Division 2000: Pavement Systems

DIVISION 2000 PAVEMENT SYSTEMS**TABLE OF CONTENTS**

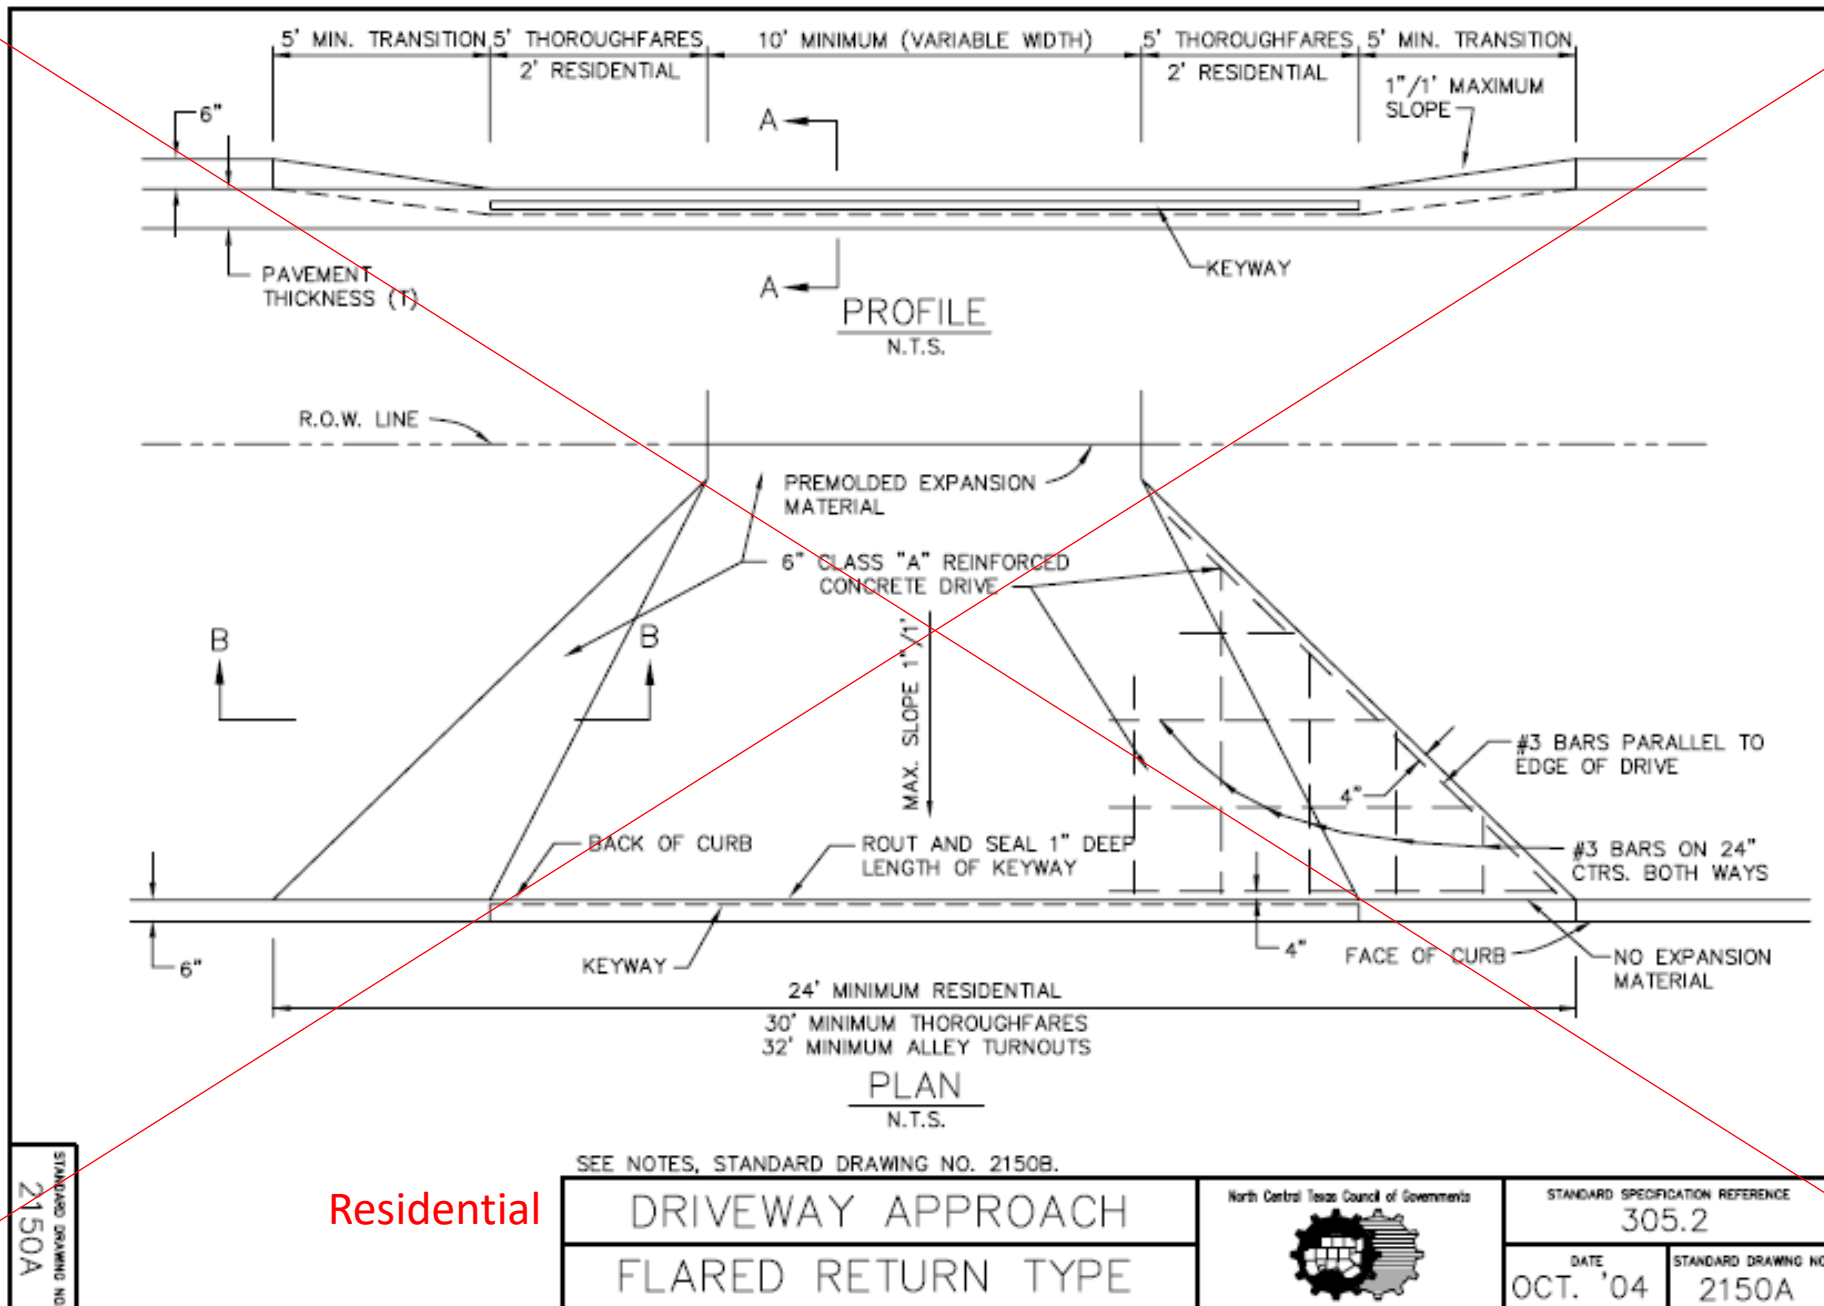
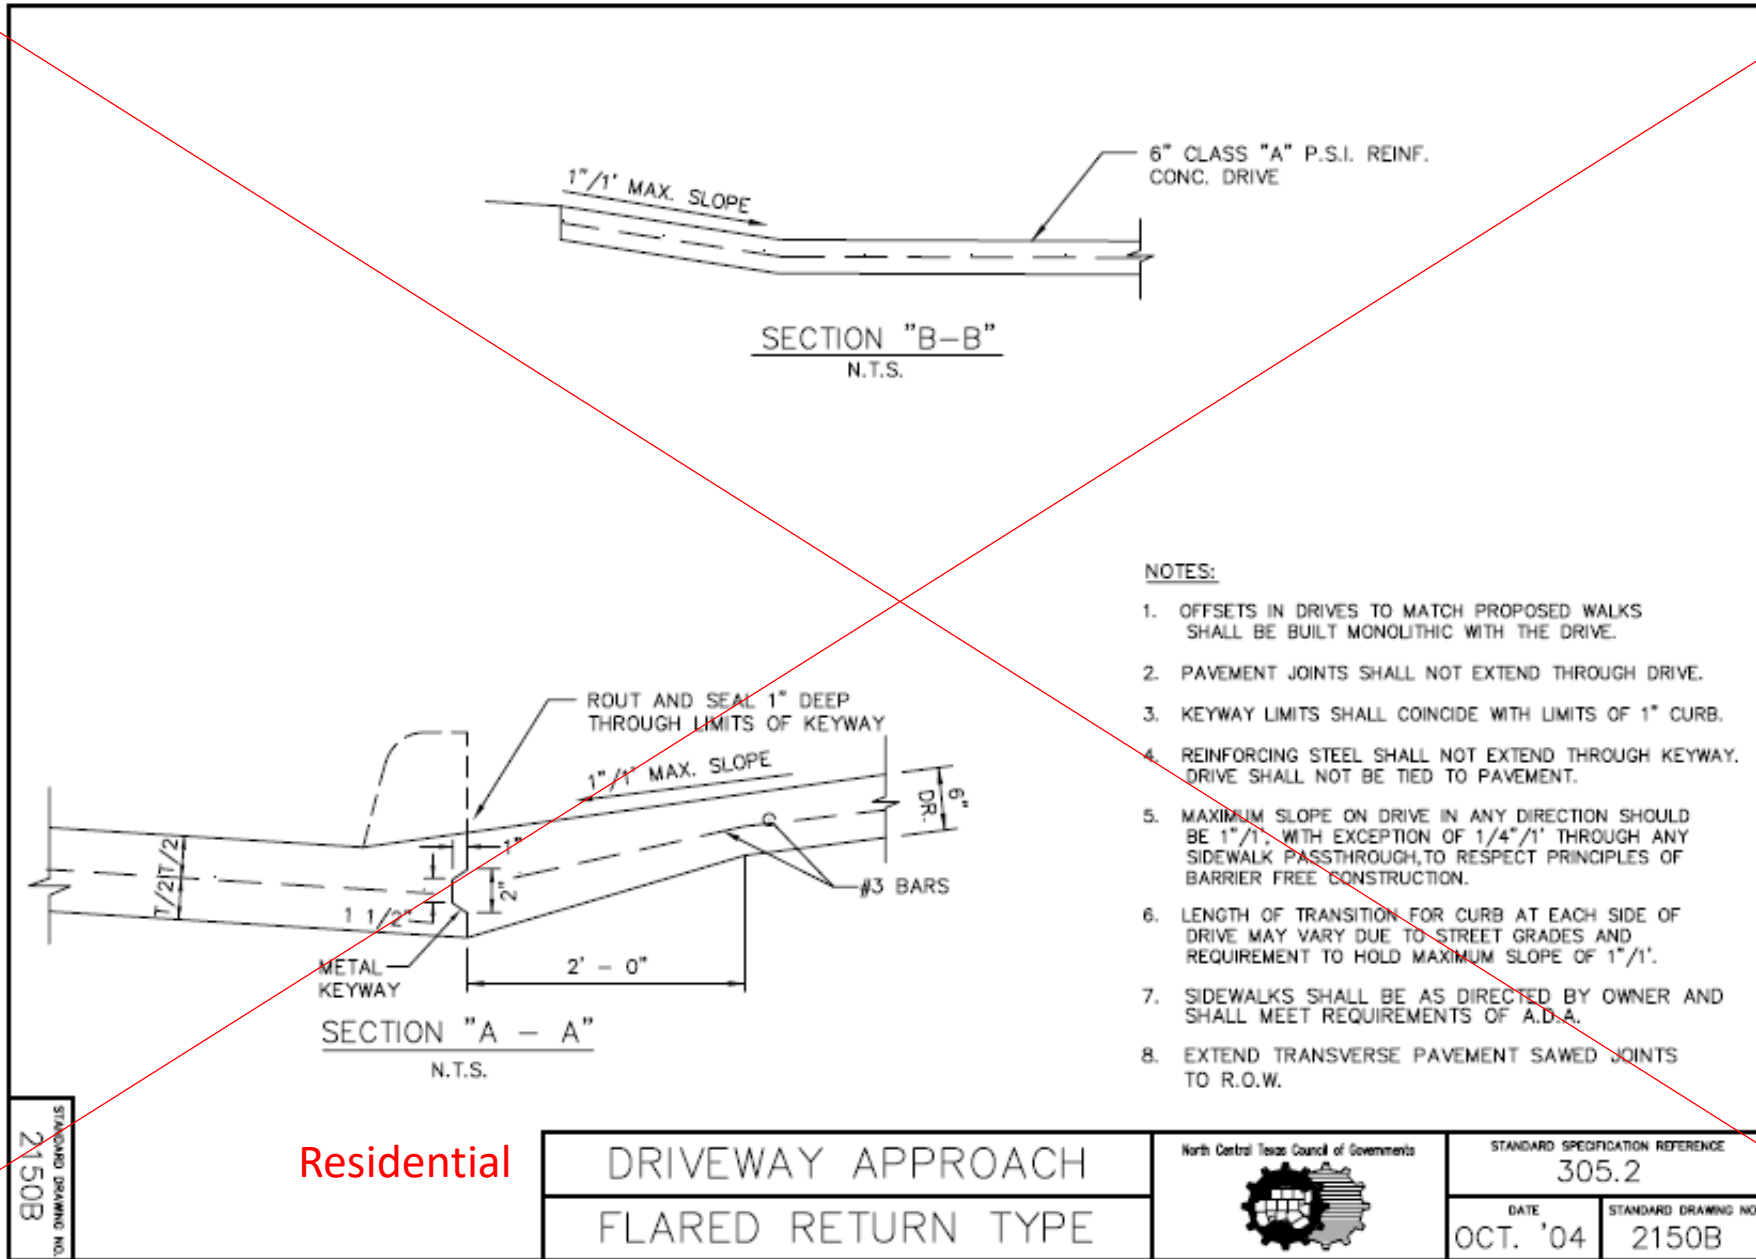
Use
Arlington
Drawings for
residential
driveway
approaches

Show
doweling
as option

Use
Arlington
Drawings for
residential
driveway
approaches

Update
2150, 2155,
2160 and to
include
residential,
commercial
and alley
approach

DRIVEWAY APPROACH RADIUS RETURN TYPE	North Central Texas Council of Governments 	STANDARD SPECIFICATION REFERENCE	
		DATE OCT. '04	STANDARD DRAWING NO. 2155

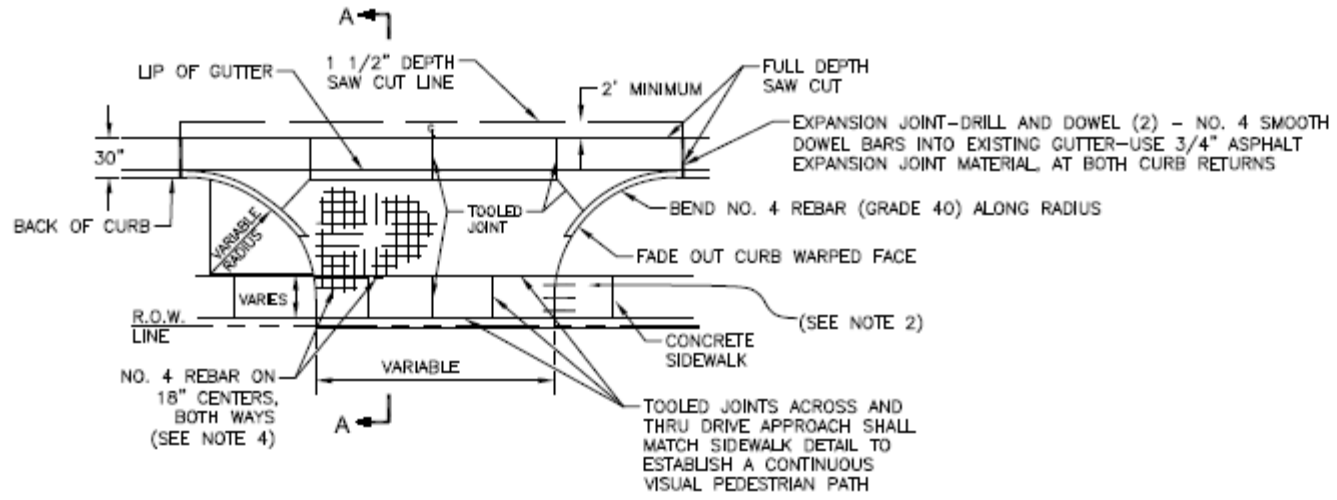
Add cross section view like 2150A

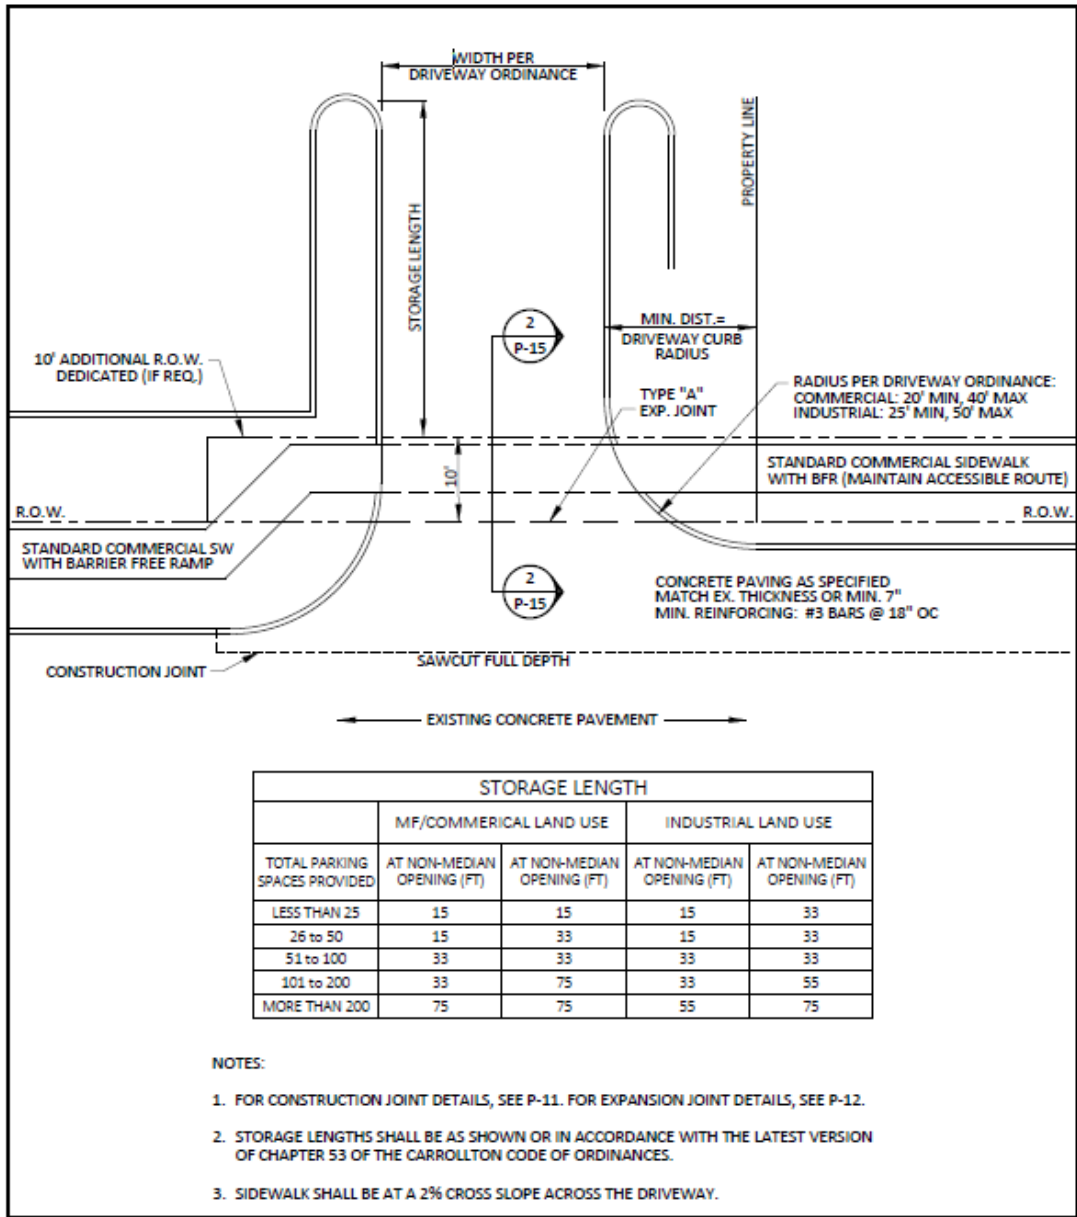
Use
Carrollton
Drawings
for
commercial
driveway
approaches

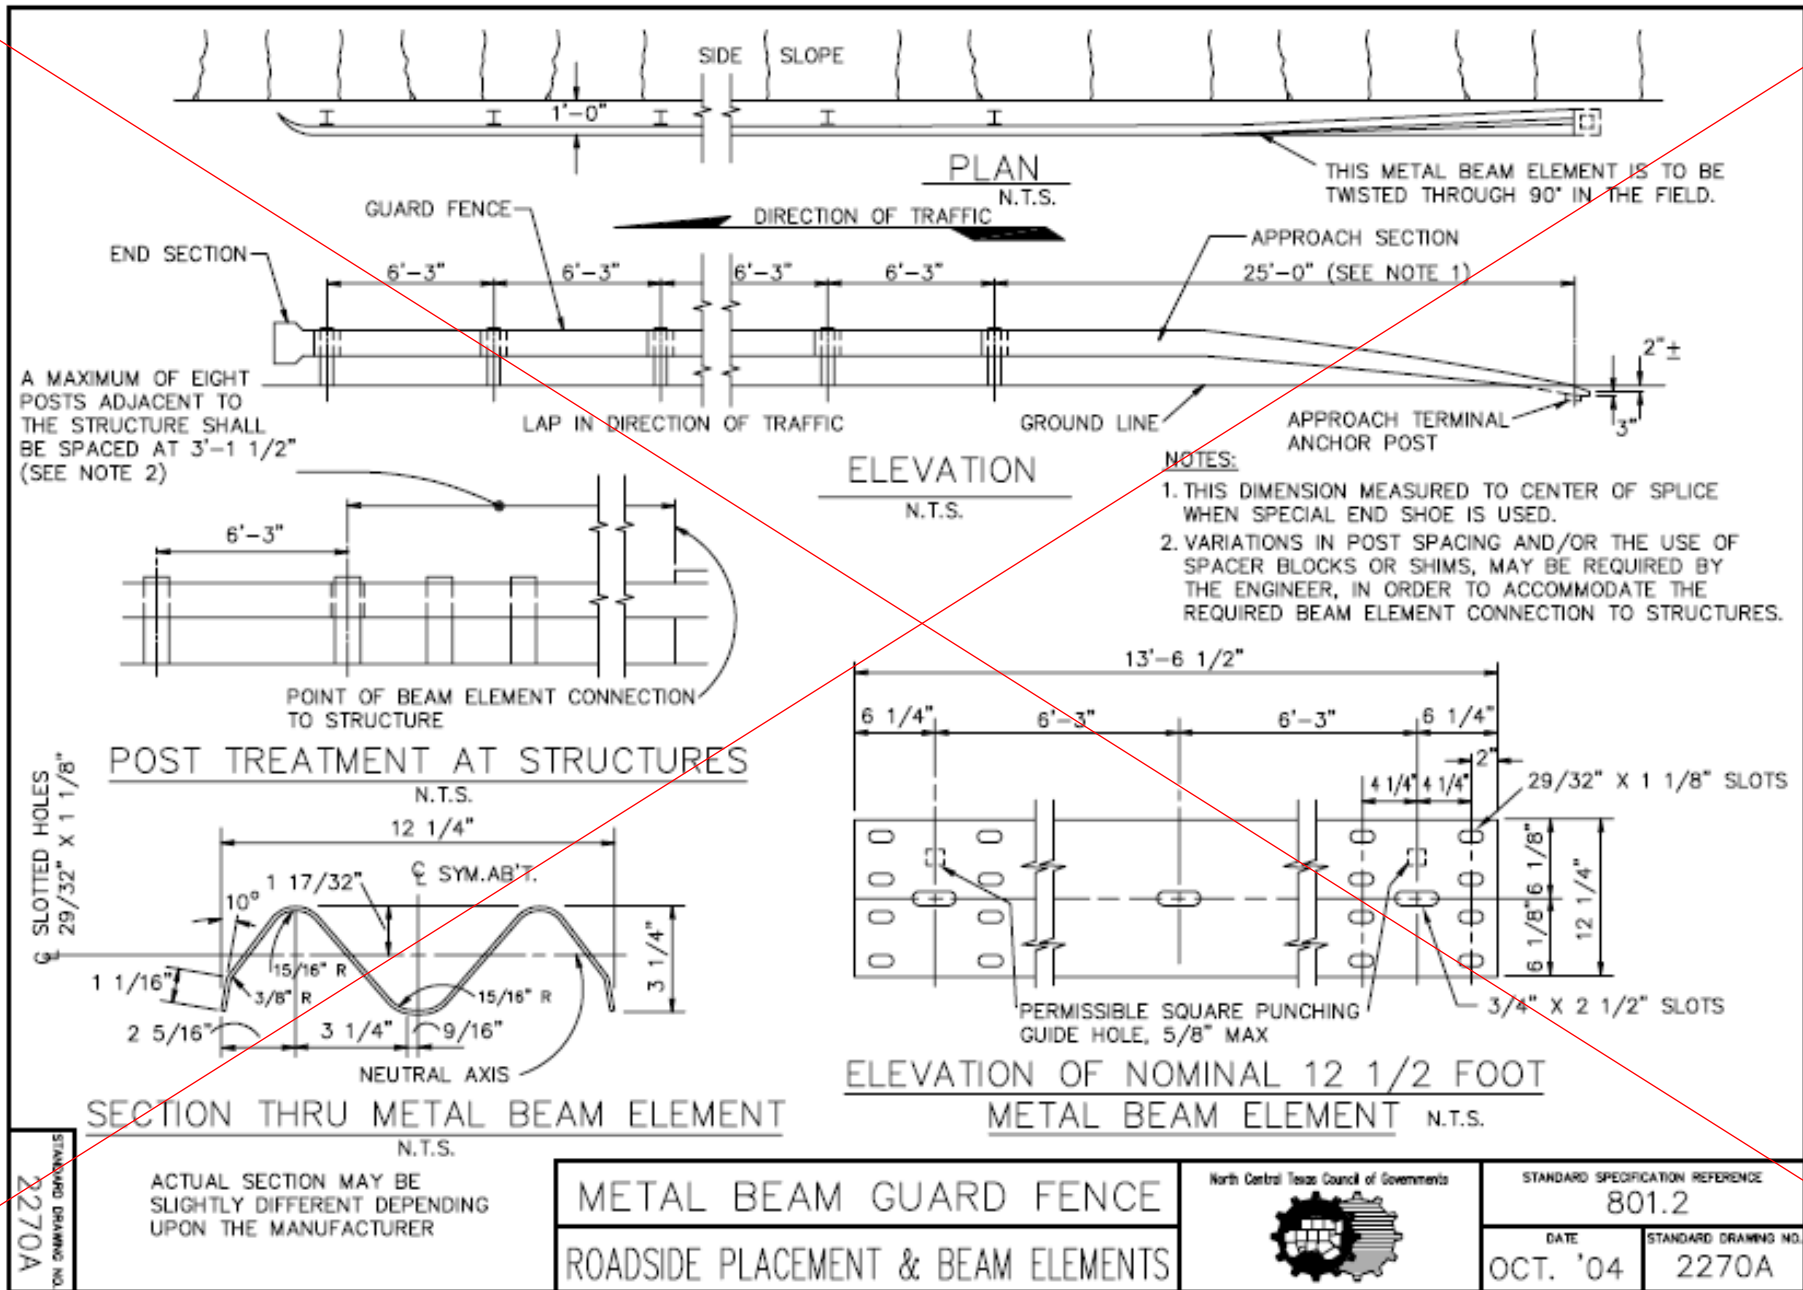
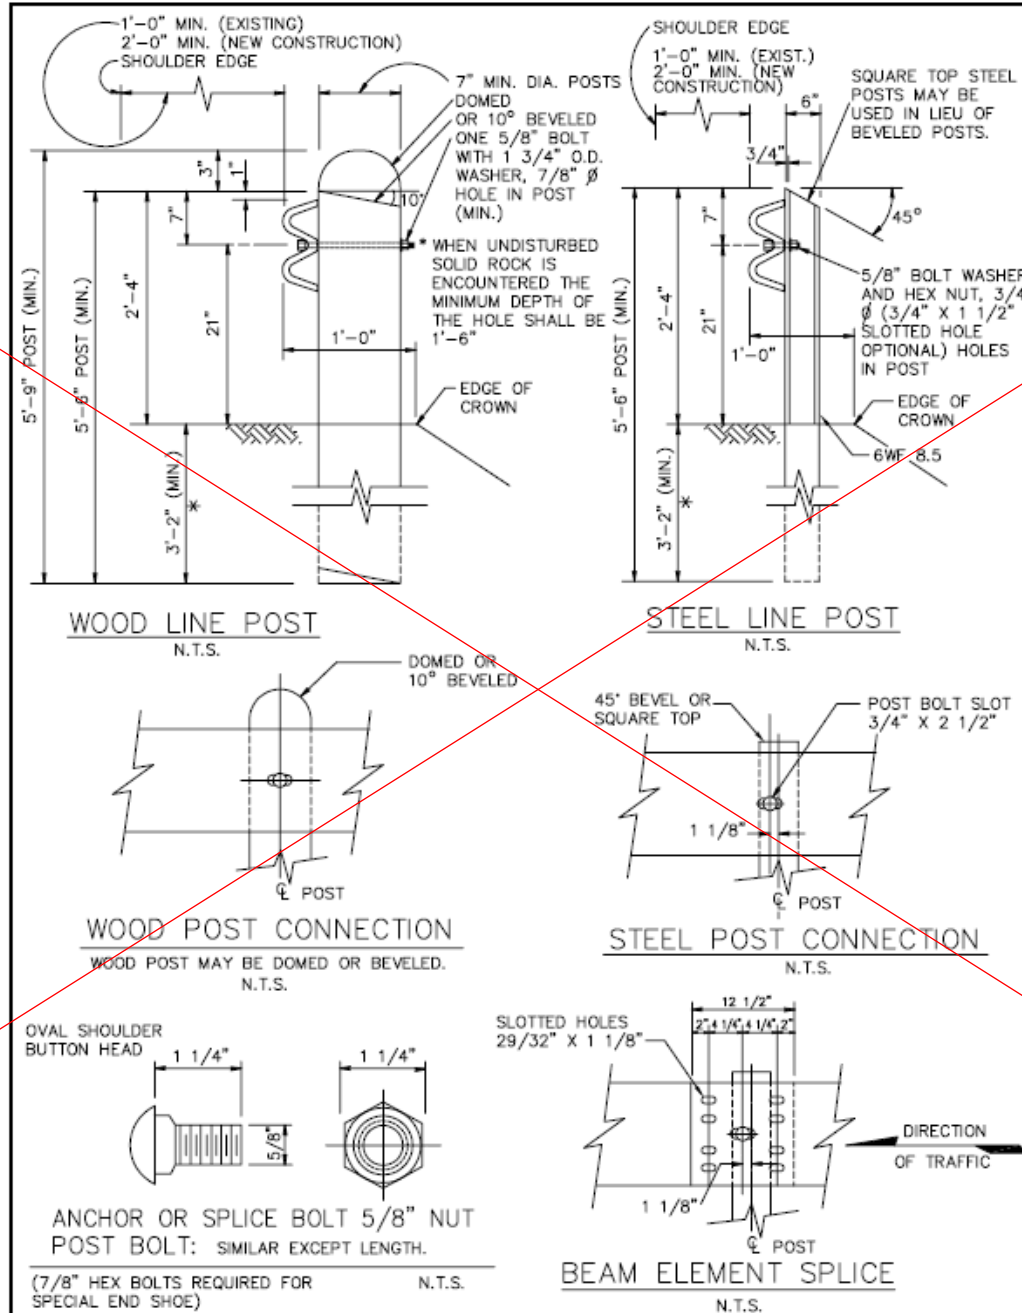
Remove and reference the TxDOT Metal Beam Guard Fence

Remove and
reference the
TxDOT Metal
Beam Guard
Fence
